**Hunter G.A Mk. II - Cabin Conditioning System - To Introduce Controller Type A (Ref. No. 27KD/510) with Enlarged Orifice (Mod. No. Normalair 146)**

(Mod. No. Hunter/1065.)

Hunter GA Mk 11 Aircraft

Cabin conditioning - Electrics, Amplifier Type FLM/A/5, (Ref No 5CZ/4335604) Introduced in place of FLM/A/1.

Drg. No. AP101B-1309-2/T2/74

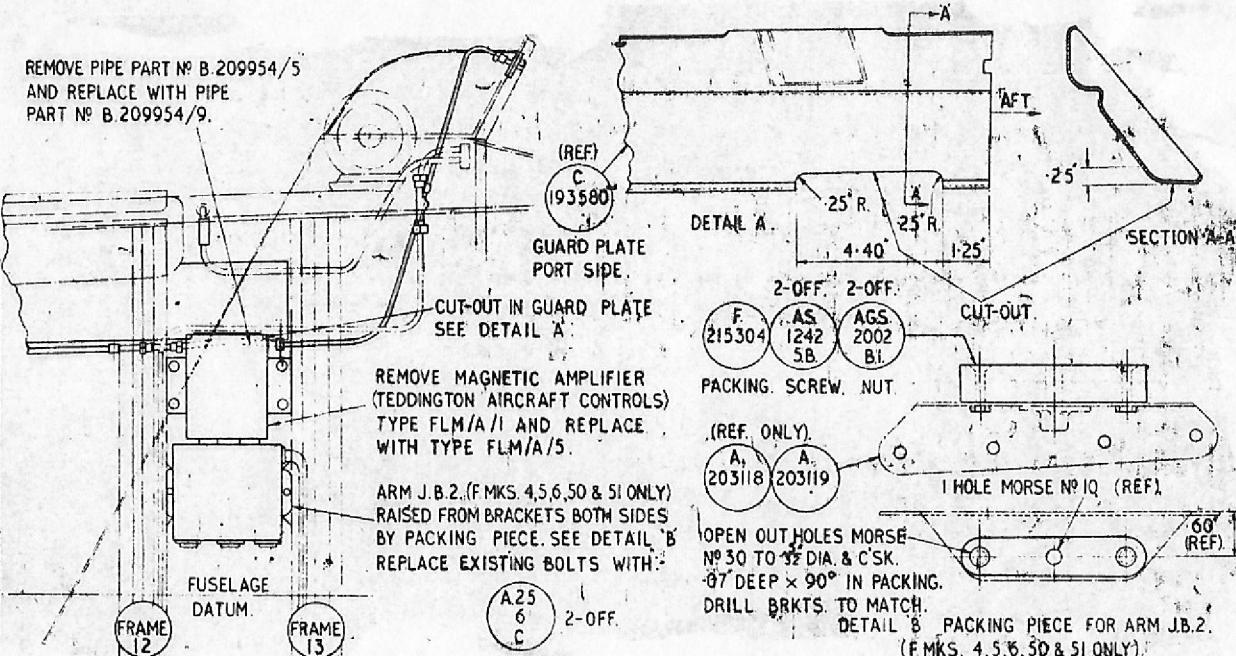
(5) Modify the guard plate, Part No C193580 as shown on the Drawing.

(6) Fit packing Part No F215304 to armament JB 2 mounting brackets, Part No A203118 on frame 13 and Part No A203119 on frame 12 using bolts, Part No AS1242/5/B and nuts Part No AGS 2002/B/1 as shown on the Drawing.
